**RE:** Building Addition, McFarland Spring Corporation  
**Address:** 280 Warren Avenue, Portland  
**CBL:** 296 F-1-18  
**Application ID:** 2011-300 (*One Solution*)

**TO:** Jean Fraser, Planner  
**FROM:** Ashley Auger, E.I.T. & David Senus, P.E.  
**DATE:** August 10, 2011  
**RE:** McFarland Spring Corporation – 280 Warren Avenue

**RE: 280 Warren Avenue – Building Addition  
Level II Site Plan Review  
Application ID Number: 2011-300**

AUTO-2

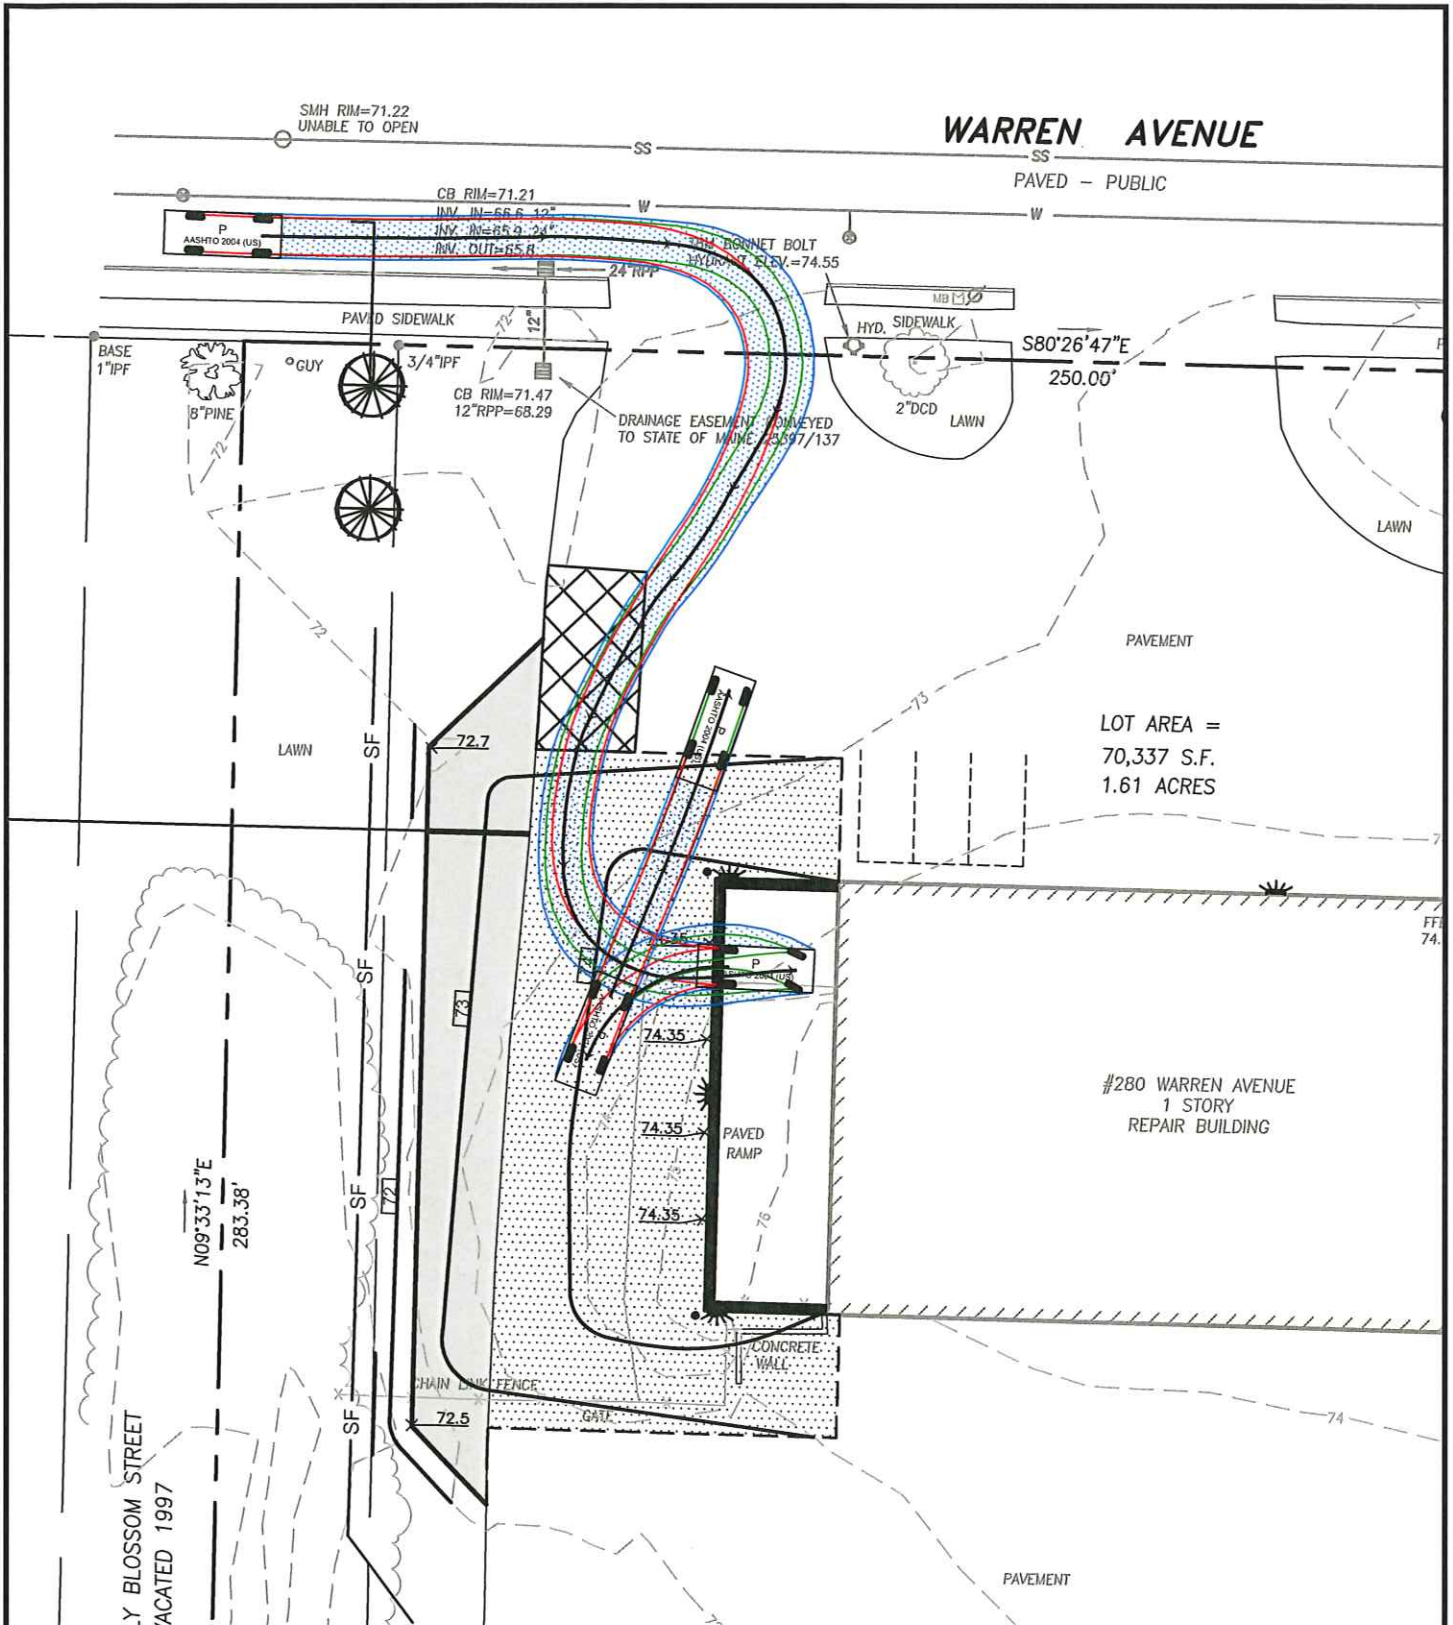
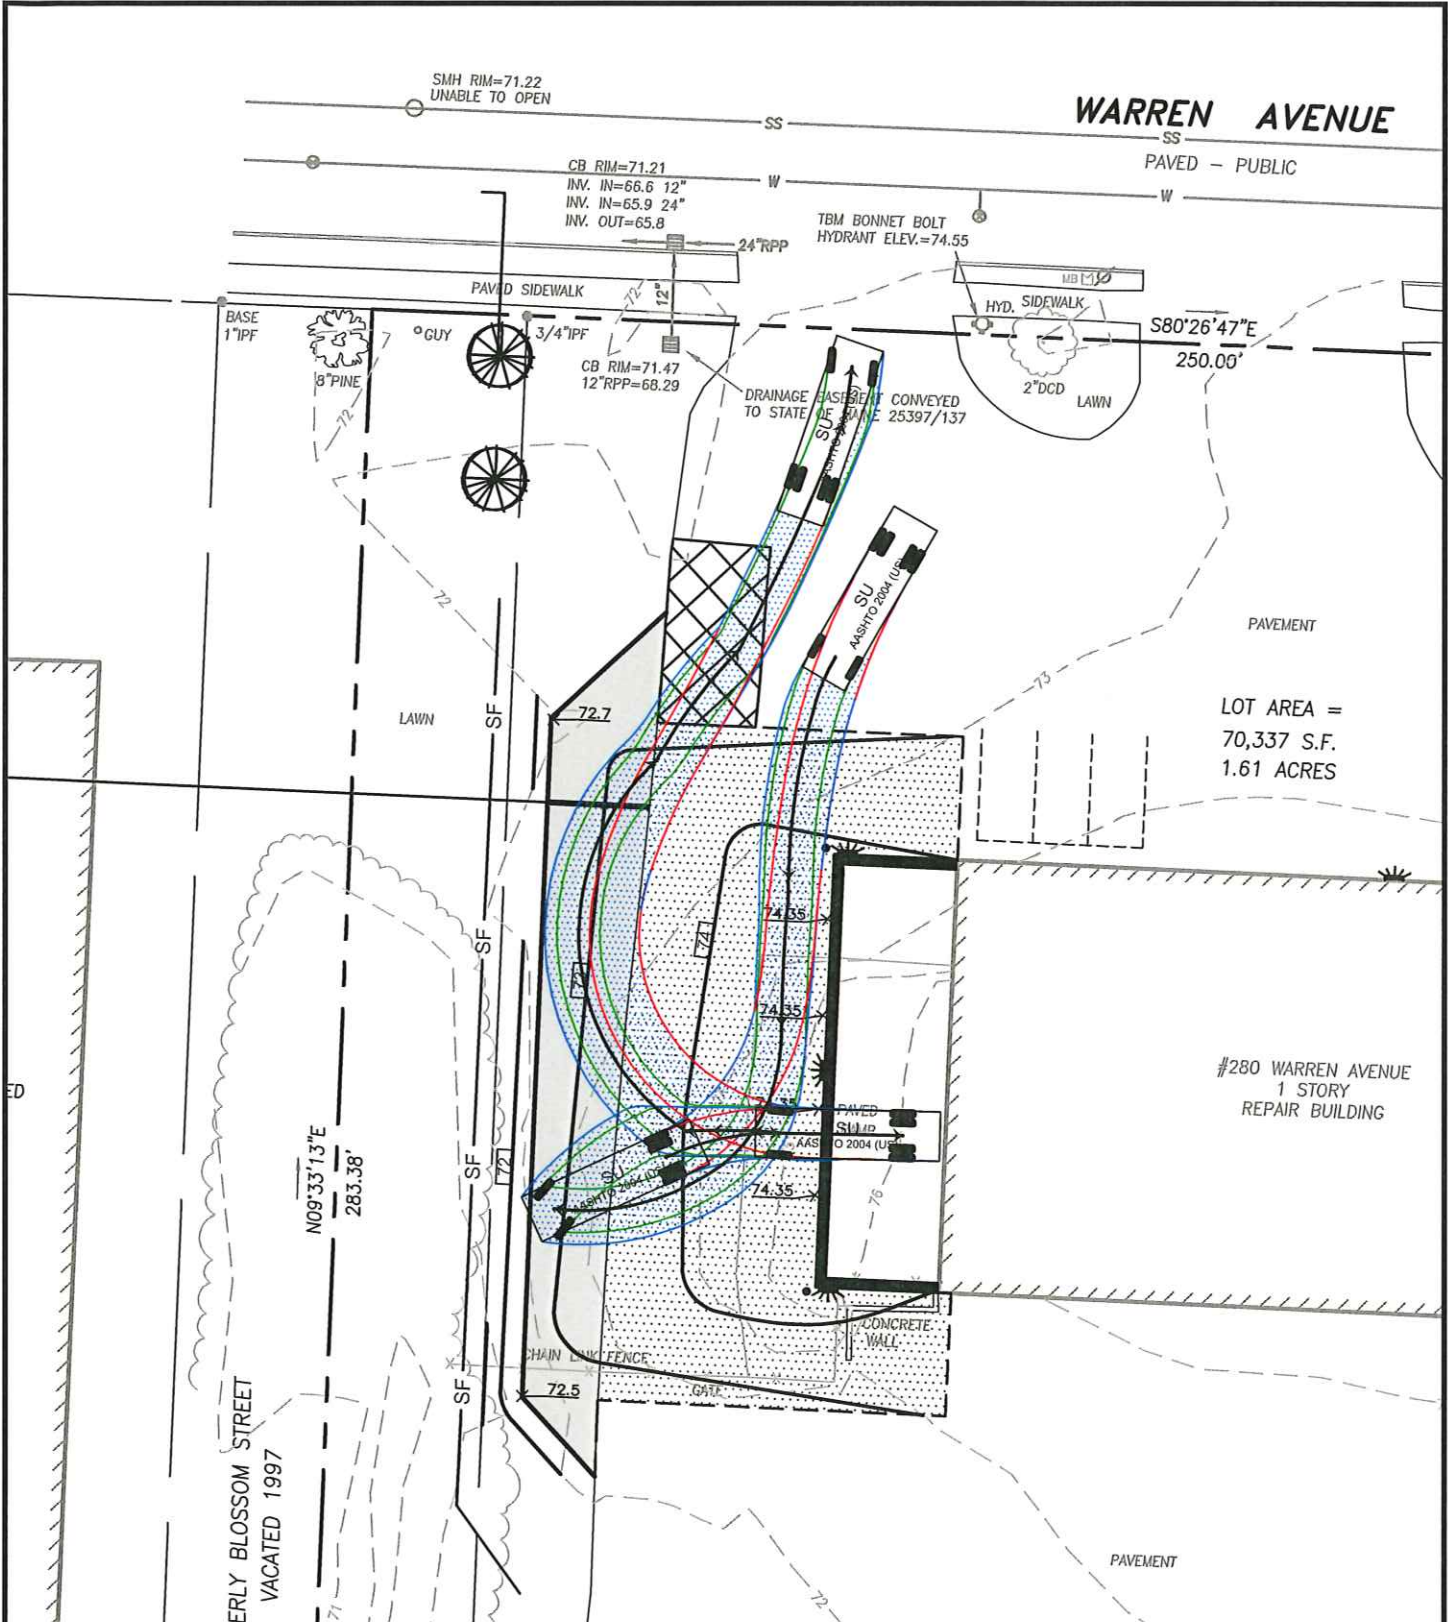
- The site currently has three access/egress points on Warren Avenue and I would suggest that one of the driveways be closed. The applicant shall submit information that documents the need for all curb cuts. Auto-Turn graphics and other supporting documentation should be provided. Based upon my site investigation, I would suggest that the westerly driveway be closed. I would note that a temporary closure plan would be acceptable, thus avoiding pavement moratorium fees. The details of this temporary program would need to be established.

- The site currently has three access/egress points on Warren Avenue and I would suggest that one of the driveways be closed. The applicant shall submit information that documents the need for all curb cuts. Auto-Turn graphics and other supporting documentation should be provided. Based upon my site investigation, I would suggest that the westerly driveway be closed. I would note that a temporary closure plan would be acceptable, thus avoiding pavement moratorium fees. The details of this temporary program would need to be established.
- Details on all designated parking spaces and circulation areas should be dimensioned and illustrated.
- Vehicle turning templates should be provided that documents the need for the pavement widening on the side of the building where the expansions is proposed.

**Status: The applicant has provided the suggested information and I have no further comment.**

**(G) GRAVEL CONSTRUCTION ENTRANCE/EXIT**  
N.T.S.

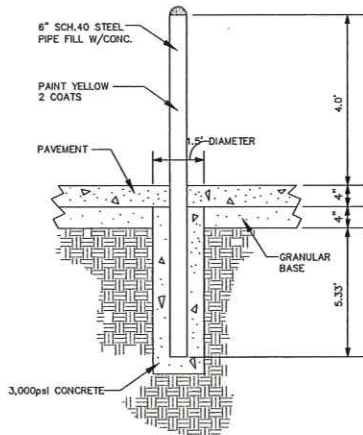
- Please provide a detail for the proposed stabilized construction exit per B-4 of the MaineDEP Erosion and Sediment Control Best Management Practices Manual.

- Please provide a detail for the proposed stabilized construction exit per B-4 of the MaineDEP Erosion and Sediment Control Best Management Practices Manual.
